Docket Number:	24-OPT-05
Project Title:	Corby Battery Energy Storage System Project
TN #:	272996
Document Title:	Corby Project Lighting Data Request
Description:	Responses to Staff questions regarding project lighting
Filer:	Doug Urry
Organization:	Tetra Tech
Submitter Role:	Applicant Consultant
Submission Date:	10/1/2026 4:16:22 PM
Docketed Date:	10/1/2026

From: Longman, Renee@Energy <Renee.Longman@Energy.ca.gov>
Sent: Thursday, September 24, 2026 5:19 PM
To: Syed, Qaim <Qaim.Syed@nexteraenergy.com>; Galindo, Sara <Sara.Galindo@nexteraenergy.com>; Omercajic, Nadan <Nadan.Omercajic@nexteraenergy.com>
Cc: Knight, Eric@Energy <Eric.Knight@energy.ca.gov>
Subject: Corby BESS: Project Lighting

CORBY BESS, LLC
CORBY 230/34.5kV SUBSTATION

LIGHTING PLAN

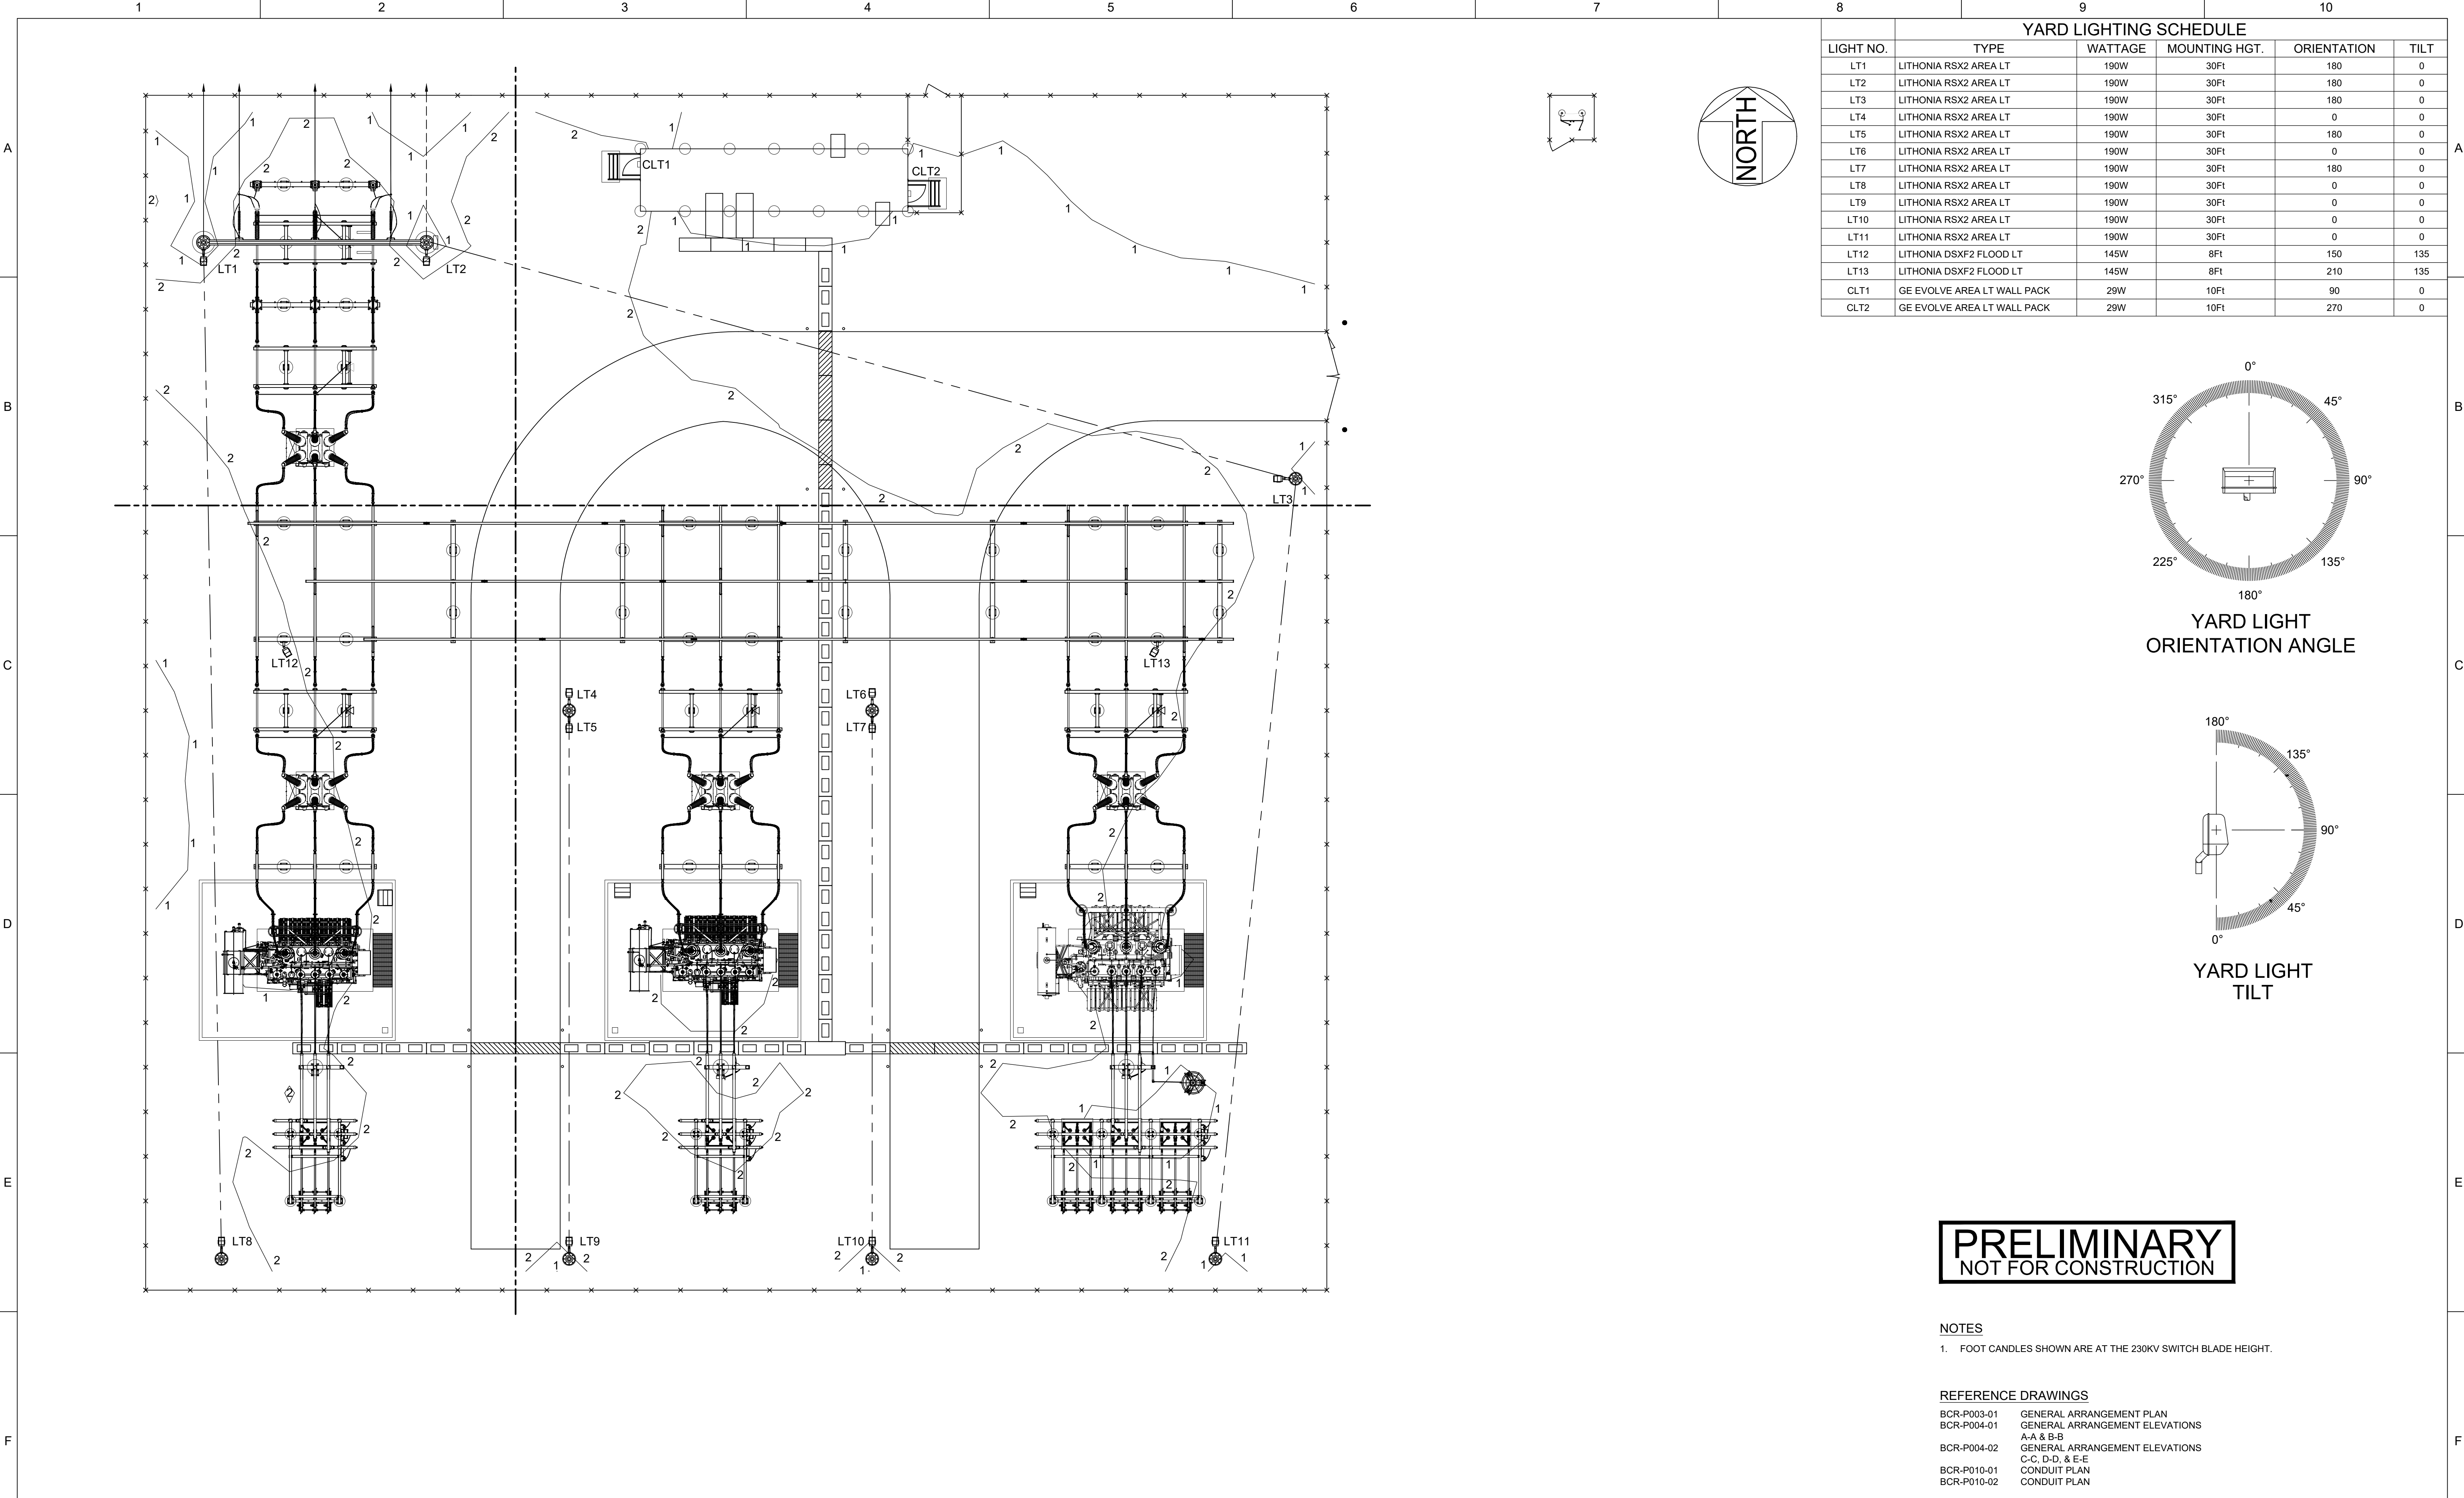
1. **Light Mounting Heights** (which is correct?)
 - Low-elevation (i.e., less than 14-ft), controlled security lighting would be installed at primary access gates and the on-site substation. (This is based on the description in the Opt-in Application, Section 2, Project Description, pages 2-7 and 2-8, TN268540).
 - The Yard Lighting Schedule on the Substation Lighting Plan identifies 2 lights with 8-ft mounting heights, 2 lights with 10-ft mounting heights, and

2. **Light Locations** (which is correct?)

- Permanent, operational lighting would only be within the Project substation. No permanent lighting would be installed at site entrance gates or within the BESS array. (This is based on Data Request Response 10.7 Data Request DR VIS-7). **This is correct. Lighting is shown only within the project substation. No lighting is shown at the site's access gates or within the BESS yard. Therefore, permanent operational lighting is limited to the fenced substation yard only.**
- Motion-controlled security lighting would be installed and allow for the site to be monitored remotely; and lights would be installed at the primary access gates, the onsite substation, and the entrance to the energy storage structure for maintenance and security purposes. (This comes from the Opt-In Application, Section 4.15, Public Services, page 4.15-4, TN259874).

11 lights with 30-ft mounting heights. **This is correct.**

The Substation Lighting Plan identifies:

- 11 lights at 30-foot mounting height: LT1 through LT11
- 2 lights at 8-foot mounting height: LT12 and LT13
- 2 lights at 10-foot mounting height: CLT1 and CLT2

YARD LIGHT
TILT

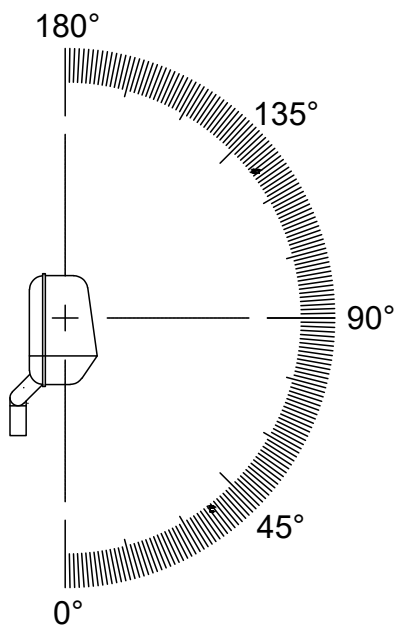
- The Yard Light Tilt diagram on the Substation Lighting Plan shows a range of 0 degrees to 180 degrees. Is that just indicating the available range or is there possible intent to tilt the light above the horizontal (90 degrees), in which case the light could become visible off site? **This is just available range, there is no intent to tilt the yard lights above the horizontal (90°), and the yard lights are not expected to direct illumination upward or increase off-site visibility. See below**
